**FIELD SERVICE CAMPAIGN – 21111**

17 August 2021

Parameter Update

IC Bus® CE Series models with Cummins® ISB engine only

**Figure 1. Cummins INSITE™**

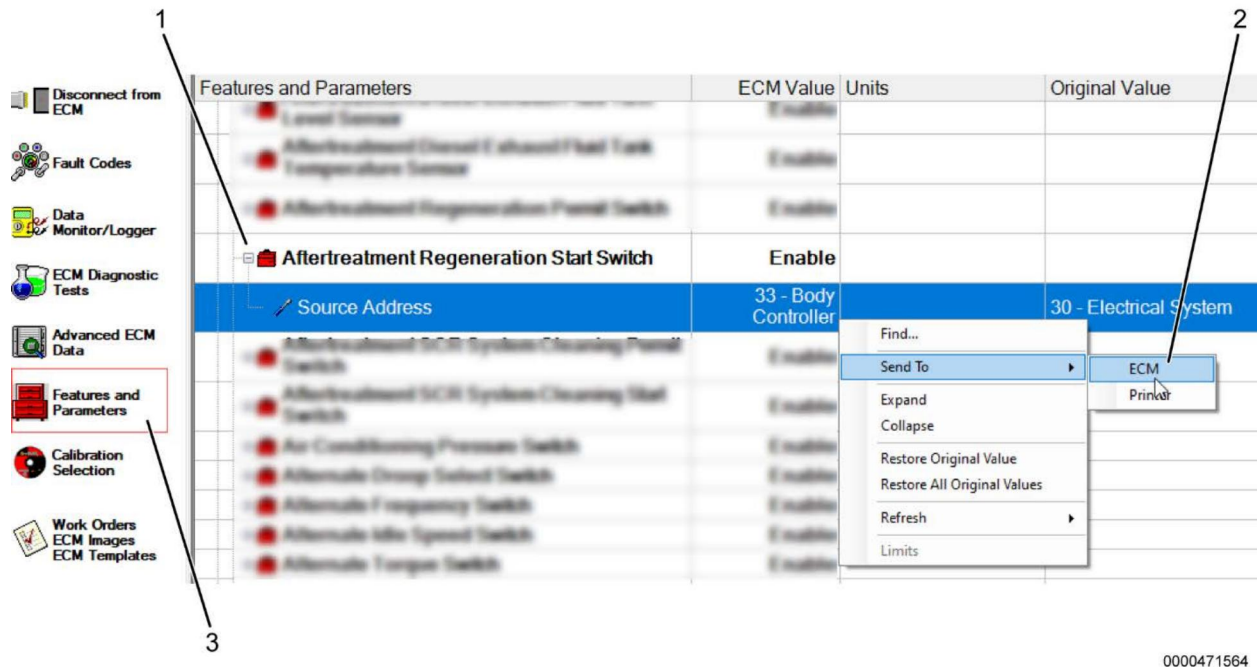
Certain IC Bus® CE Series models may have been programmed with the incorrect parameter setting that may impact regeneration switch functionality.

11. Select **FEATURES AND PARAMETERS** menu item (Figure 1, item 3) and look for **AFTERTREATMENT REGENERATION START SWITCH** (Figure 1, Item 1) under Features and Parameters column on the left side of the screen.
12. Right-click on **AFTERTREATMENT REGENERATION START SWITCH** (Figure 1, Item 1) under Features and Parameters column, select **SENT TO** and select **ECM** (Figure 1, Item 2) to begin updates.
13. Follow the on-screen instructions.
14. Clear any inactive and / or previously active faults that are found after programming. Only perform diagnostics or procedures on active faults.
15. Turn ignition to Key OFF position.
16. Disconnect interface connector from diagnostic port.
17. Disconnect battery charger / maintainer from vehicle battery.
18. Remove wheel chocks.
